**TRANSMITTAL OF MEETING HANDOUT MATERIALS FOR
IMMEDIATE PLACEMENT IN THE PUBLIC DOMAIN**

To meet with Westinghouse to discuss construction

INCONSISNCIES NOTED WITH AP-600 DOCUMENTS

SFP Drawing:

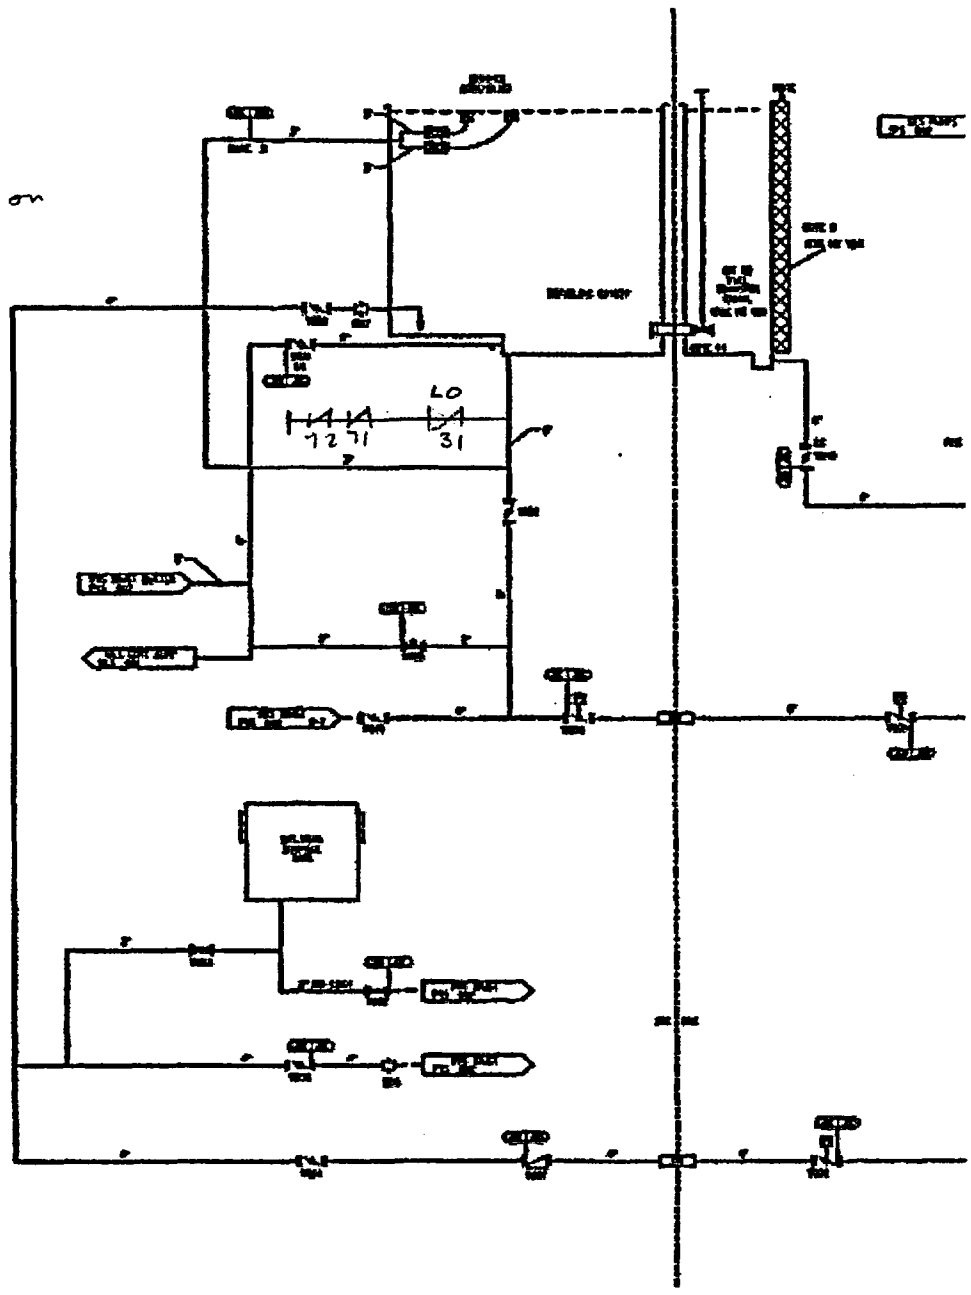
4. Tier 1 Figure 2.3.7-1, SFP Cooling, specifies that a number of pipe segments are classified ASME Section III but there is no listing of ASME components in Table 2.3.7-1. Most of the other sections list the system valves that provide the Code break change. (The drawing in the Tier 2 document does not include line numbers or Code break flags.) Shouldn't the valves be included in the Table?

5. Tier 1 Table 2.3.7-1 lists Line L030 as the Reactor Cavity Drain line but it appears that the line should be labeled Refueling Cavity Drain Line. The same condition exists in the AP-1000 Tier 1 DCD which has two lines (L030 & L040) listed Reactor Cavity Drain lines. The piping shown on the P&ID for both plants are connected to the refueling cavity. A new Section 9.1.3.3.8 was added to the AP-1000 SFS System Description that discusses a line from the Reactor Cavity to the Steam Generator Compartment but this is apparently a different line not shown on the P&ID. A new line with a LO manual valve and two check valves as discussed in 9.1.3.3.8 is shown on AP-1000 Figure 9.1-6 connected to the refueling cavity but its opposite end appears to be blank flanged. (The Reactor Cavity Volume for these designs is somewhat different than earlier designs and is shown on Figures 19.39-5 & 6.)
